In the Application of)
)
Inventor: Rene Langhans) Examiner: C. Goodman
) Group Art Unit: 3724
For: ROTARY CUTTING UNIT)
)
Serial No.: 08/883,685)
) File No. 2821-193
Filed on: June 27, 1997)

APPELLANT'S REPLY TO EXAMINER'S ANSWER

PETITION TO THE COMMISSIONER

Fig. 1

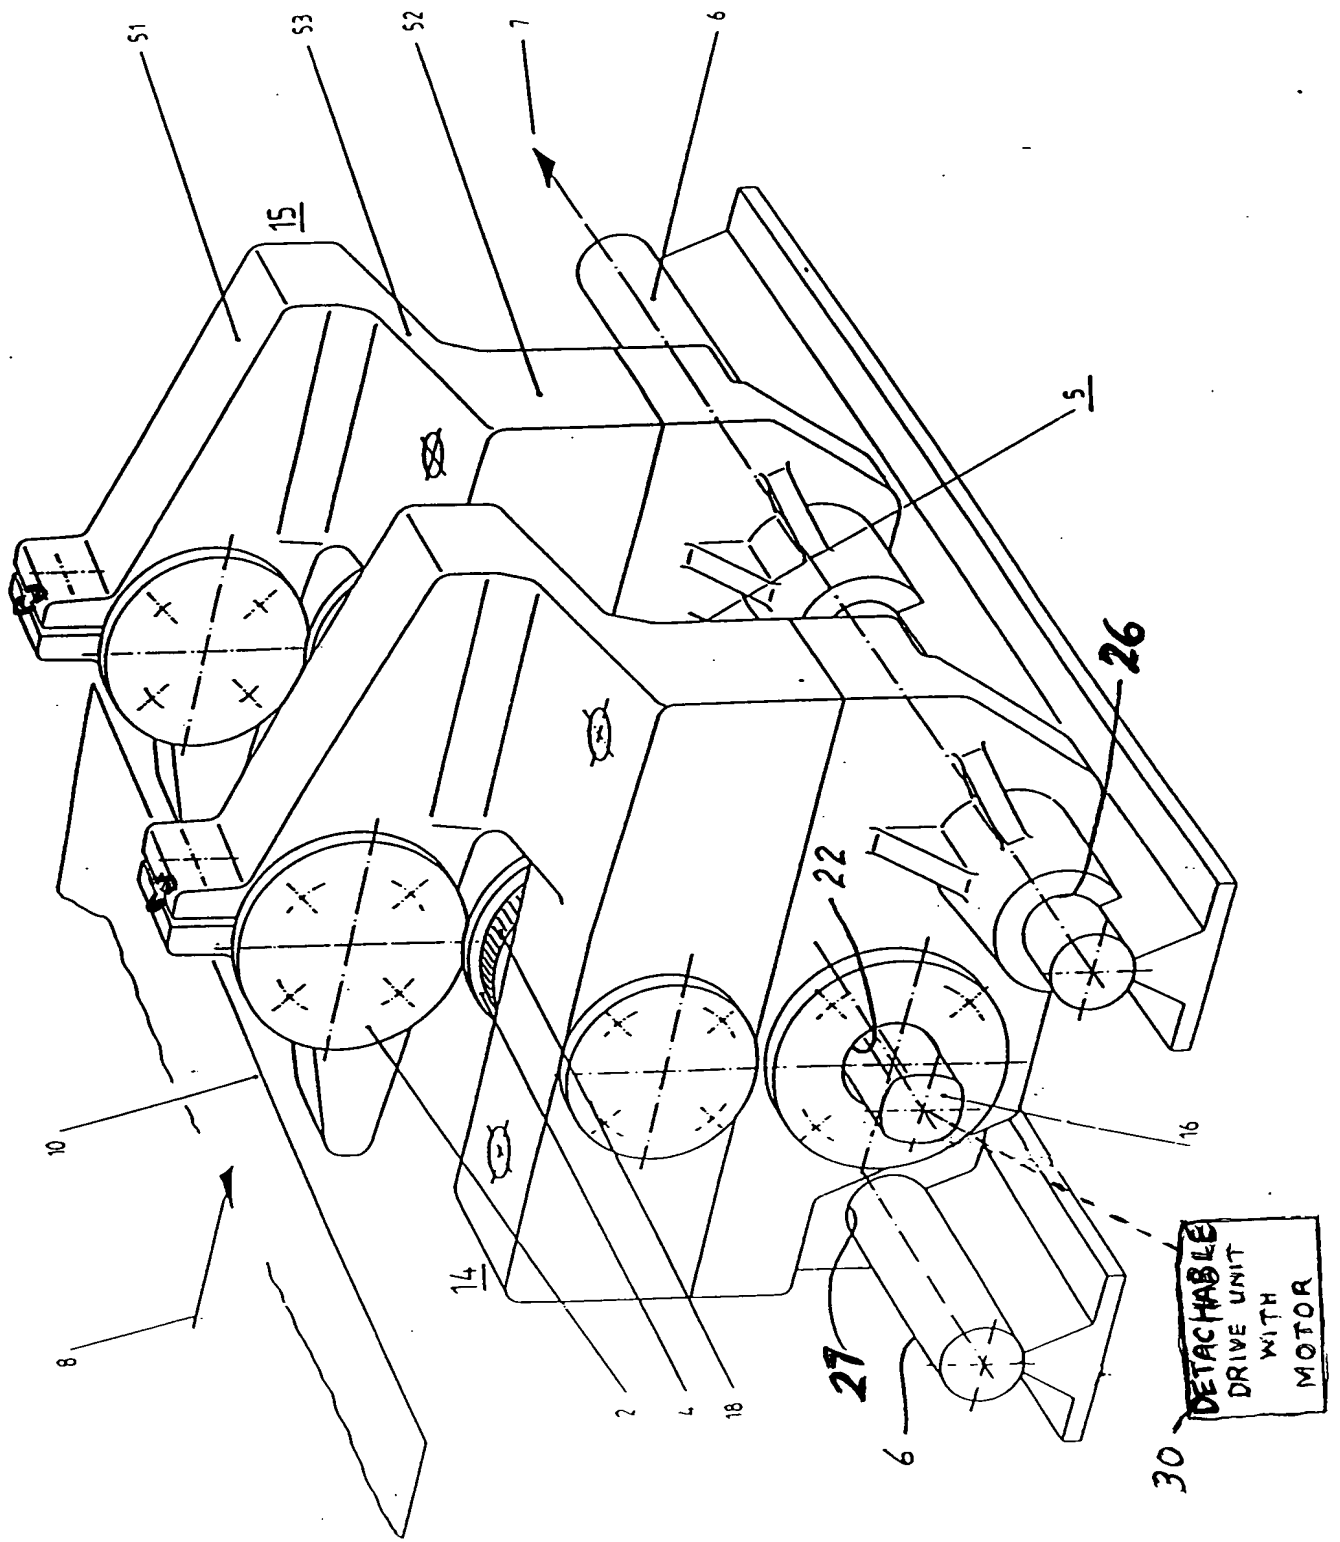
OBJECTION No. 2: "The drawings are objected to because references "26" and "27" should be interchanged to maintain consistency with the depiction in FIG. 1. Correction is required."

OBJECTION 2: Examiner objects to reference numerals "26" and "27" in Figure 1 which should be interchanged.

ADDITIONAL AMENDMENT: Figure 1 was amended to include the slot for receiving pin wrench 25. (The slot for receiving pin wrench 25 was included in the original application in Fig. 4 as described below in paragraph 4.)

The Examiner has objected in the Final Office Action dated March 8, 2000 to Applicant's amendment to Figure 1 to include the slot for receiving pin wrench 25 and states that the slot was not previously shown. Figure 4 as originally filed clearly shows both pin wrench 25 and the slot for receiving pin wrench 25. Figure 4 shows pin wrench 25 in the position as used; that is within the slot for receiving the pin wrench 25. Applicant's amendment to Figure 1, or in the proposed Figure 5, both include the longitudinal section of the slot for receiving pin wrench 25, previously disclosed in Figure 4, does not constitute the entry of new matter.

APPLICANT'S AMENDMENT: Figure 1 was amended by interchanging reference numerals "26" and "27".

In response to paragraph 4 - 6 of the Office Action dated March 8, 2000, revised informal Figures 1 and 2 are enclosed which identify angle α and switch the references to components 26 and 27. The labeling for drive unit 30 has been changed by adding the word "detachable," and a slot for the pin wrench has been added to the cutter frame 51. The changes are marked in red. No new matter has been added to the drawings by this revision.
